Downtown Code DRC Meeting of 3/4/2021 Item # 1

Request	DTC Modifications & Overall Height Modification
Project Name	Voorhees Residential Development – Tower 2
Council District	19 – O'Connell
Requested by	Ryan Terrell, ESa
Staff Reviewer	Islas
Staff Recommendation	Approve with conditions and defer without all conditions

Figure 5: Voorhees Master Plan

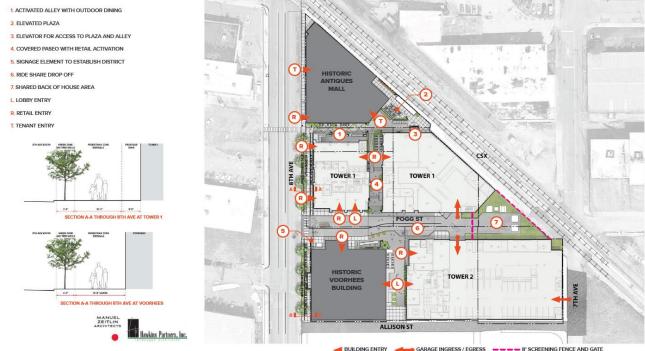
The Voorhees Master Plan proposes a 20-story residential building consisting of approximately 328 apartment units, ground-level retail space, office space, and both underground and structured parking for a total of 395 vehicular parking spaces. This building is referred to as Tower 2.

The proposals for Voorhees Tower 2 and Tower 1 along with the renovations of the Historic Antiques Mall and Historic Voorhees Building are intended to create a unique master plan site. Retail activation and outdoor dining at the base of each building, along with a covered walkway through Tower 1, allows for an engaging pedestrian experience.
